STAFF RECOMMENDATION

3605 Westbrook Avenue

Application: New Construction—Addition

District: Richland-West End Neighborhood Conservation Zoning Overlay

3605 WESTBROOK AVE. - LEFT ELEVATION

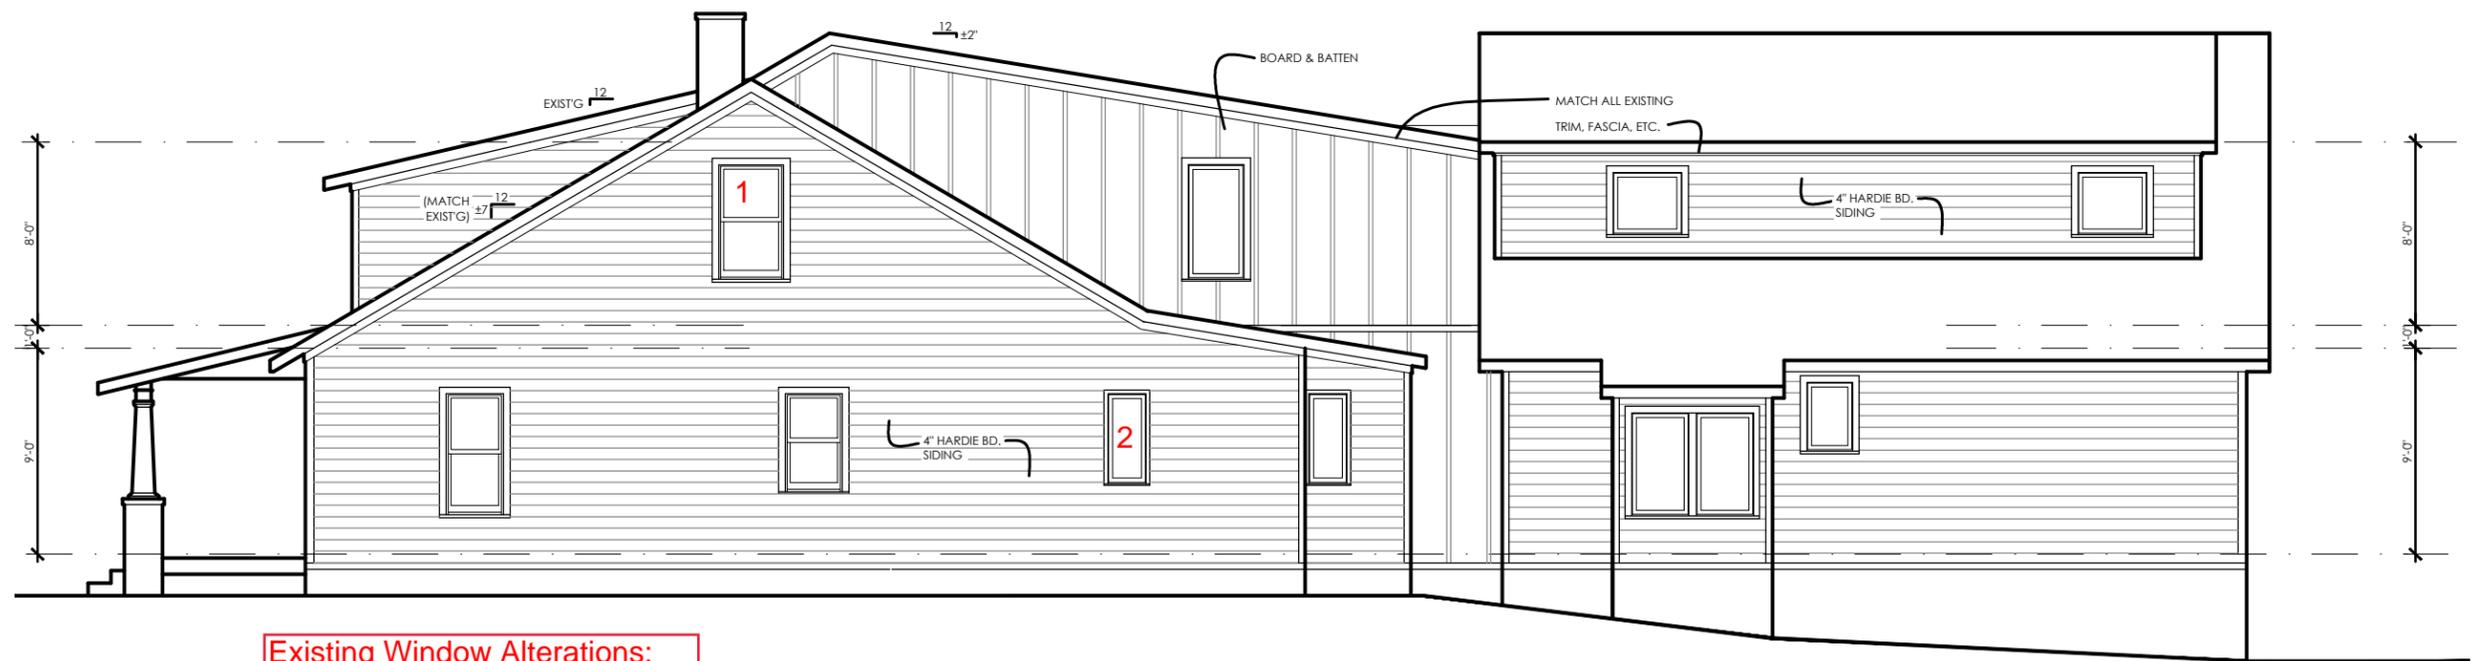
The plans also indicate that the windows in the upperstory gable fields will be made larger, and that on the first story a new door will be added on the left side and the size of a window on the right side will be altered. The Commission has approved minor alteration of windows near the rear of historic buildings and has allowed for upperstory window openings to be enlarged to meet egress. Staff finds the proposed window alterations to be consistent with previous approvals.

The rear addition will be located at the rear of the building, stepped in two feet (2') from the left and right side walls of the historic house before extending back. On the left side, the addition will extend back seven feet, seven inches (7'-7") then step in an additional fifteen feet (15') before continuing further back.

The left side of the addition's rear gable wing will also have a shed-roofed dormer. The left side wall and face wall will be stepped in as with the right side, but the side wall nearest to the front will not step in. This component will not be visible because of the inset of the addition and the orientation of the historic house.

3605 WESTBROOK AVE. - RIGHT ELEVATION

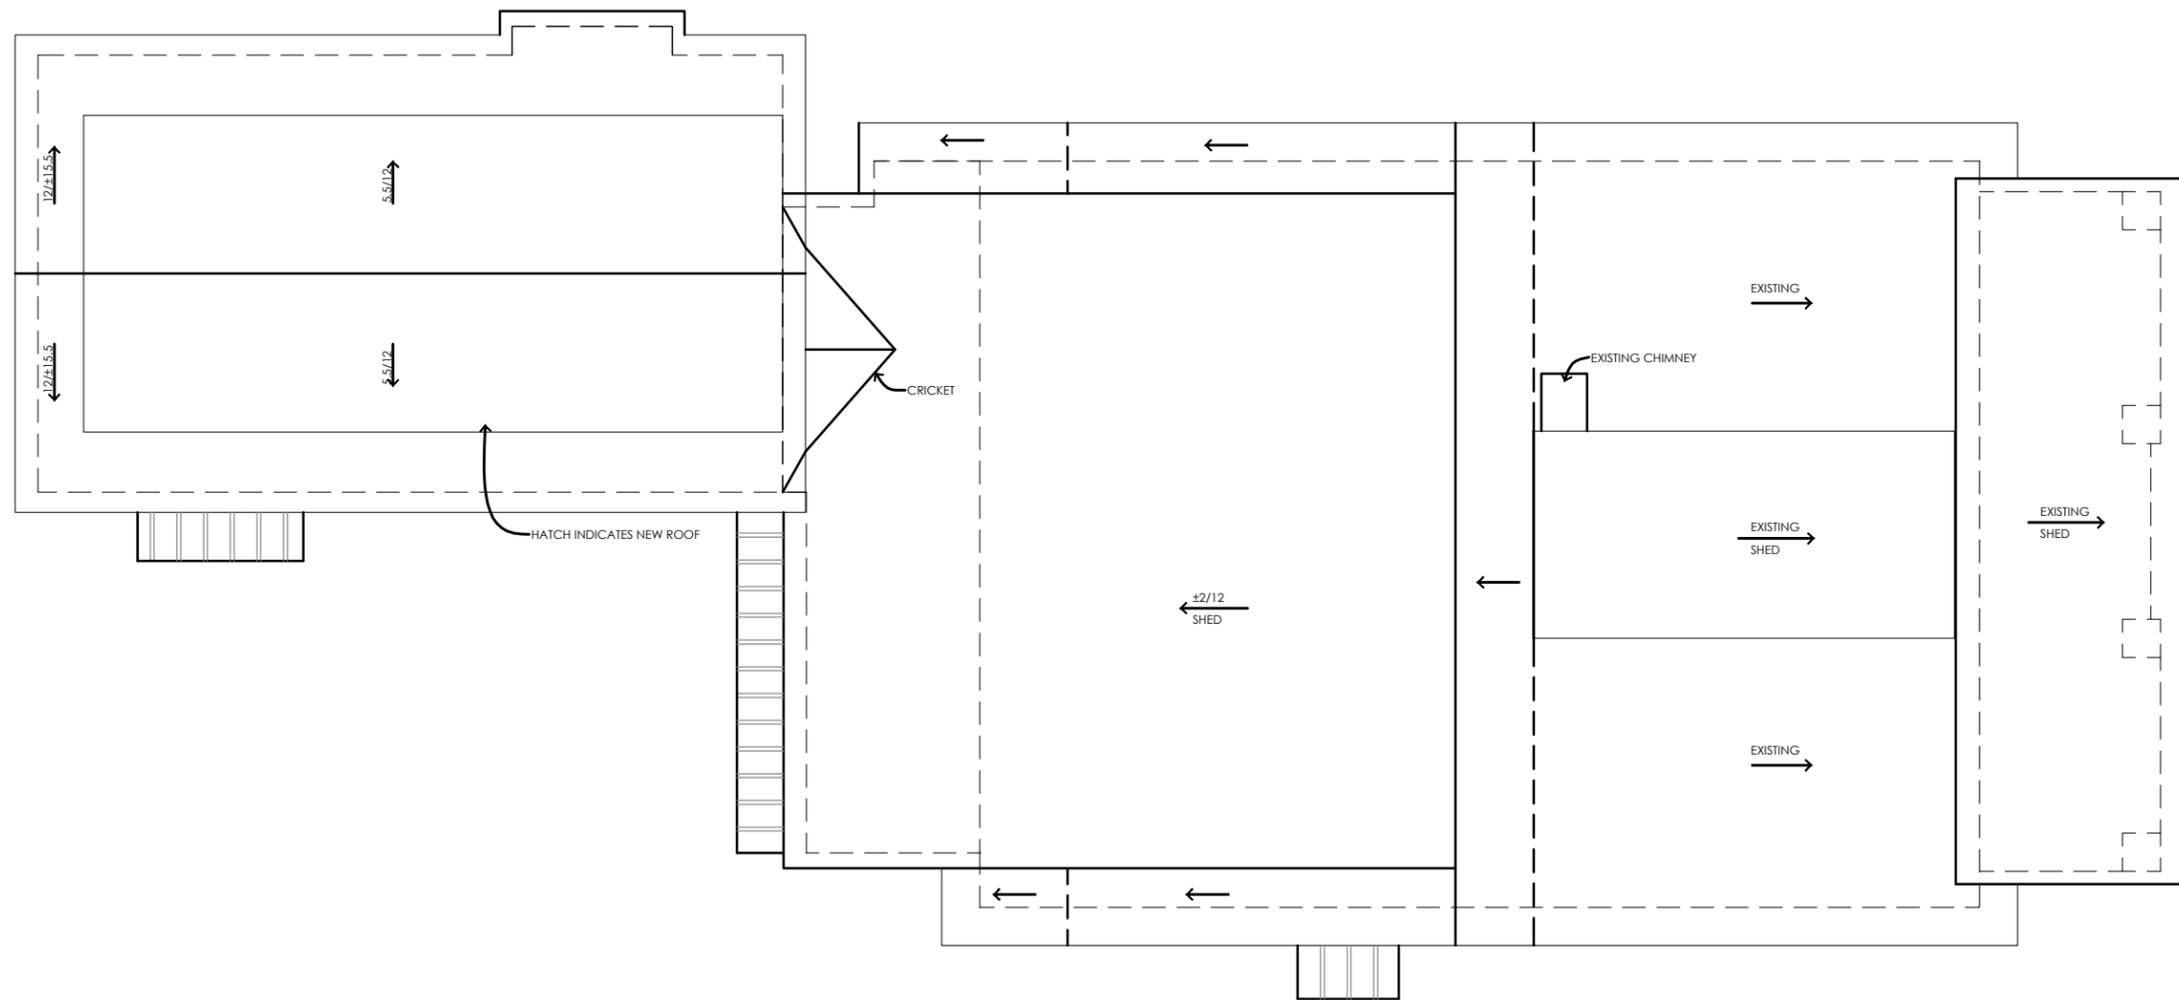
On the right side, after an alcove stepped in two feet (2') going back four feet (4'), the addition will step out seven feet (7') to the right, making it five feet (5') wider than the historic house.

Typically, it is not appropriate for additions to be wider than an historic house, especially when that addition is also taller than the historic house. This house, however, has a very unusual orientation with the lot being wedge-shaped and narrowing to the rear and with the house sited on an angle, not matching either side or the front property line. As a result, the rear yard diminishes on the left side and grows to the right, which justifies the location of the proposed addition to the right of the primary mass.

Height & Scale: Because the rear addition will be stepped inside the shadow-line of the house on the left side, only the right side will be visible from the right of way. The addition will have a one and one-half-story form with an eave height matching the original eave height of the existing house. The upperstory will be gabled with a shed dormer on the right side, with the side walls stepped in four feet (4') from both sides of the primary roof plane and the "face wall" stepped two feet (2') back from the wall below. Stepping in the walls of the dormer helps minimize the scale and keep the addition subordinate to the historic house.

Proportion and Rhythm of Openings: The proposal includes some alteration of the window sizes and locations on the sides of the historic building. Staff recommends that

the applicant work with staff to reduce the window pattern changes, especially in the front half of the building.
